Technical Service Bulletin			
Edition: Final V1	TSB#: (ECR1871&1903)	Issue date: April 06, 2023	Page 1 of 2

Title: Peristaltic Pump & Support Standardization

Old Version: 6000049	New Version: 6000044

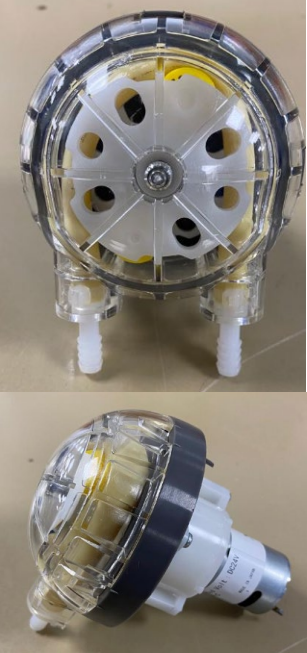
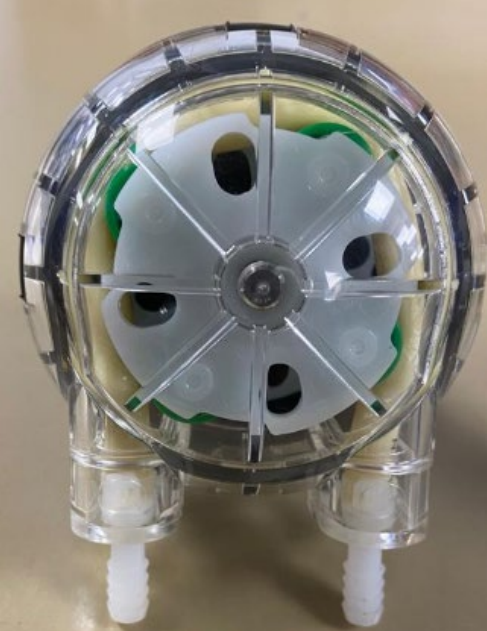
Change peristaltic & support to standardize auto steam solution between the different platforms.

Both changes are backwards compatible.

We recommend adjusting the pump speed in the technical menu after installing the new peristaltic pump, the settings are similar, but it is recommended to make a double check.

OLD Part – no longer available:	NEW Part – now available:	For Machine Types:
60000046 Peristaltic Pump 3 Rolls 24V	60000044 Peristaltic Pump 24V 4 Rolls	Diamant Pro Onyx Pro
60000049 Peristaltic Pump 24V		
260673_Peristaltic_Pump_Support	21004128_Chassis_Support_Peristaltic_Pump
